# Brocade Fabric OS v5.0.4

## Release Notes v1.0

April 5, 2006

**Figure 14-1** Accessing Performance Graphs

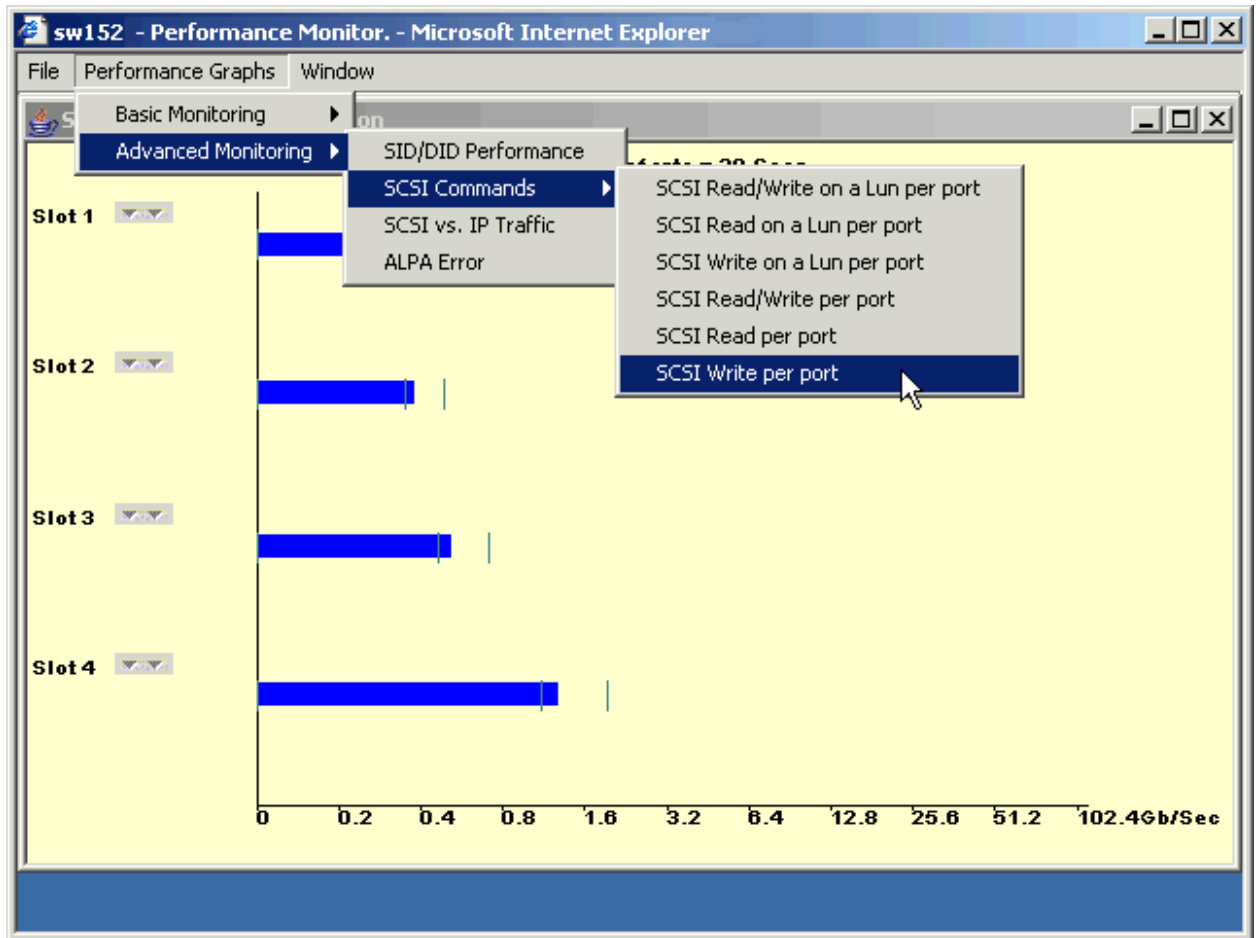
On page 14-3, add this paragraph after the first paragraph:

Port throughput utilization is represented by a horizontal bar for each selected port, which gets longer or shorter depending on the percent utilization for that port at the last poll time. Thin short vertical intersecting bars give a historical perspective by representing the highest and lowest values reached for each selected port since the graph was opened. A third bar between them represents the average of all values polled. (See Figure 14-1.)

On page 14-3, replace Figure 14-1 with this one:
